**Exception Request No.: 141**  
**Section: WMNF**  
**Town: Easton**  
**Highway: NH 116 and NH 112 (Tier 3)**  
**Station: 878+25 to 880+00**  
**Drawing No.: WMNF C120**  
**Survey Report Cross Reference No.: WMNF C120**  
**Exception Type: Alignment in Pavement**

EXCEPTION 141-ALIGNMENT IN PAVEMENT  
 NPT WMNF-UNDERGROUND ALIGNMENT  
 WMNF SECTION-STA. 878+25 TO STA. 880+00±  
 SCALE: H. 1"=30', V. 1"=10'

EXHIBIT A

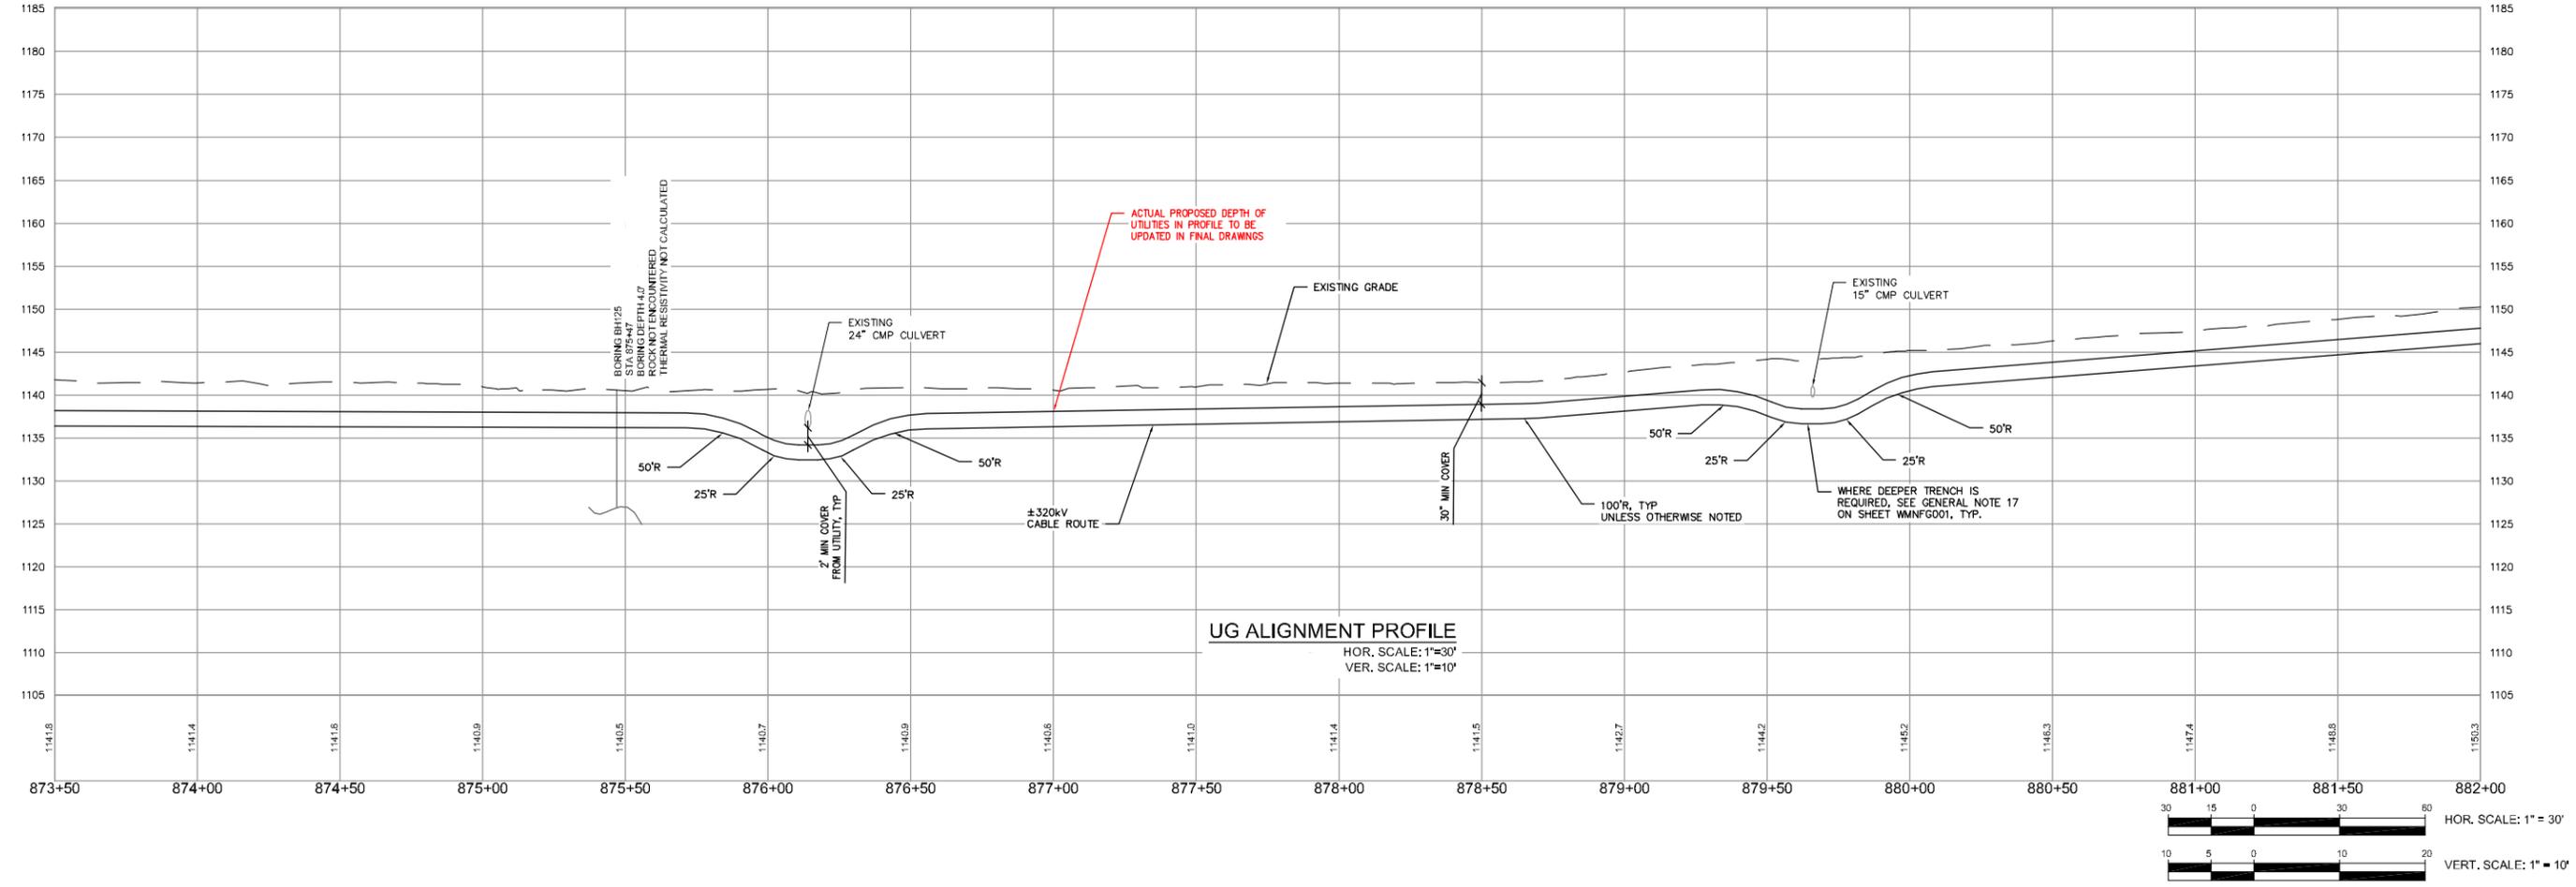
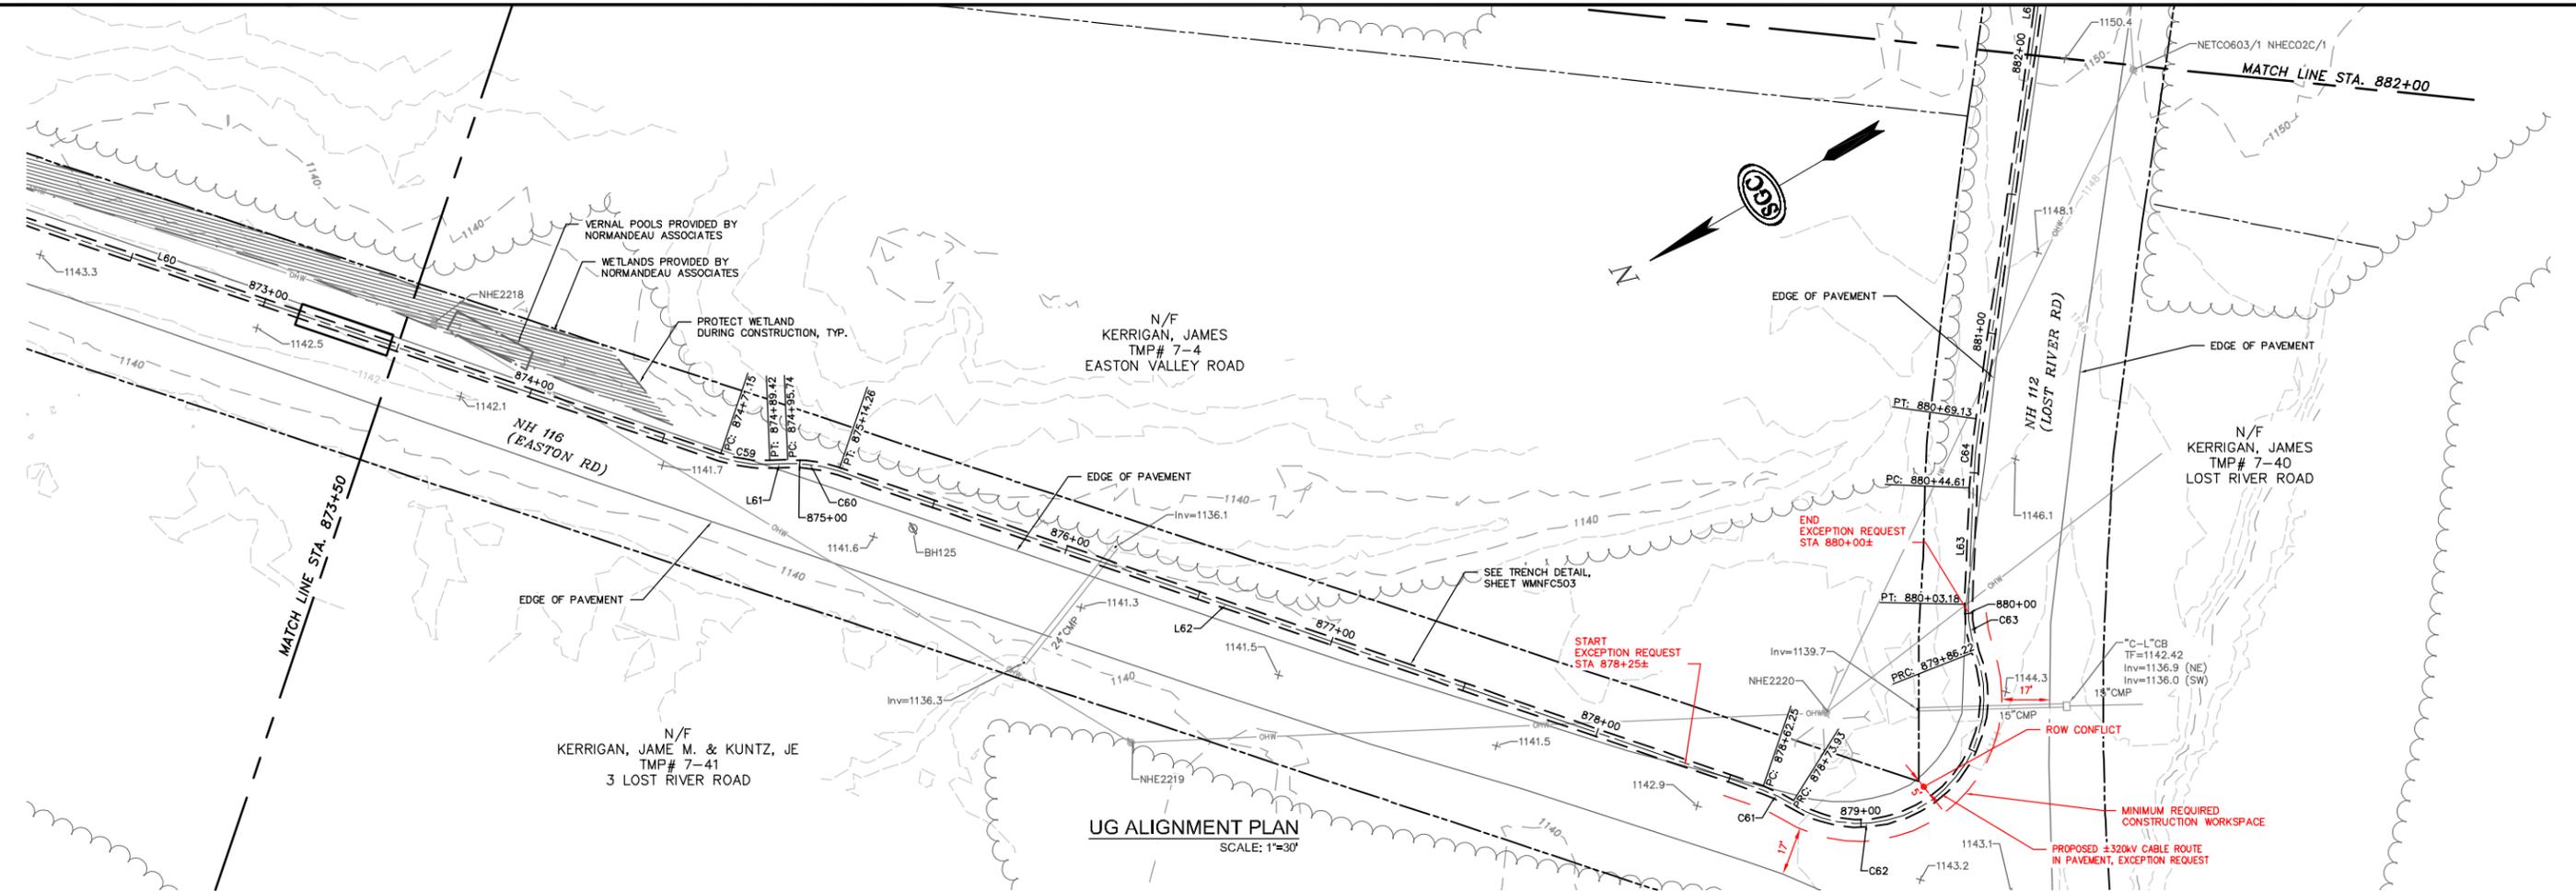
NPT is requesting an exception from the UAM guidelines for the location of the cable trench in the pavement at the intersection of Highway NH 116, Easton Road and Highway NH 112, Lost River Road from STA 878+25 to 880+00 of the NPT WMNF underground alignment section. (See Exhibit A.)

Due to limited ROW space and minimum cable bend radius, construction outside the pavement is not practicable because NPT does not have the necessary property rights to construct outside the NHDOT ROW. The proposed alignment is located beneath the pavement at a 5-foot offset from the east side ROW corner of the intersection.

At this location, the duct bank alignment turns south from NH 116 to NH 112. The duct bank is located on the inside of the corner to prevent the need for a crossing through the intersection. However, on the inside corner there is less than 5-feet from the NHDOT ROW corner to the edge of pavement. The alignment is located outside the pavement on either side of the bend at to keep as much of the duct bank out of the pavement as practicable but the location of the edge of the NHDOT ROW relative to the edge of pavement prohibits the installation outside the paved area at this corner. (See Exhibit A.)
